Official Recall Notification U.S. Federal Boat Safety Act

Mercury Diesel Vessel Sensor Harness Replacement

Mercury Diesel VIP vessel sensor harness connection

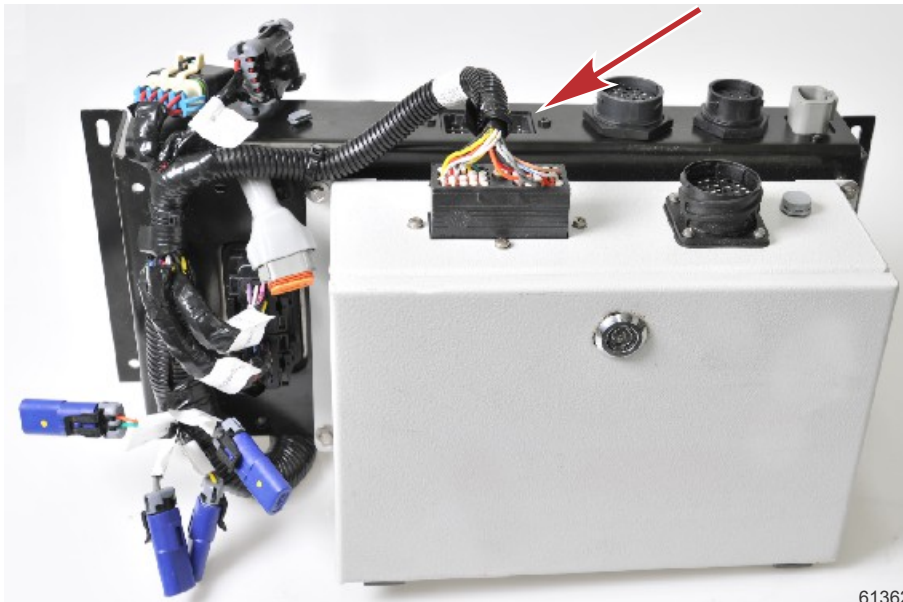
1. Locate the vessel interface panel (VIP) on the 2.0L, 2.8L, or 4.2L engines, or the vessel adapter assembly (VAA) on TDI engines. Refer to the pictures following for identification.
2. Identify the vessel sensor harness by its connection point at the VIP or VAA.

NOTE: Many installations have an extension harness between the VIP or VAA and the vessel sensor harness. The extension harness does not require replacement. Follow the extension harness to locate the actual vessel sensor harness.

3. Unplug all auxiliary sensors and devices from the harness. Loosen the Allen retaining screw and unplug the 24-pin connection from the VIP, VAA, or extension harness.
4. Connect the new vessel sensor harness 24-pin connector to the VIP, VAA, or existing extension harness. Tighten the Allen retaining screw to secure the connection.
5. Reconnect all auxiliary sensors and devices to the new vessel sensor harness, making sure all connectors seat properly.
6. Start the engine and verify function of the DTS shift actuator, trim sensor, and any other auxiliary sensors that are connected to the harness.
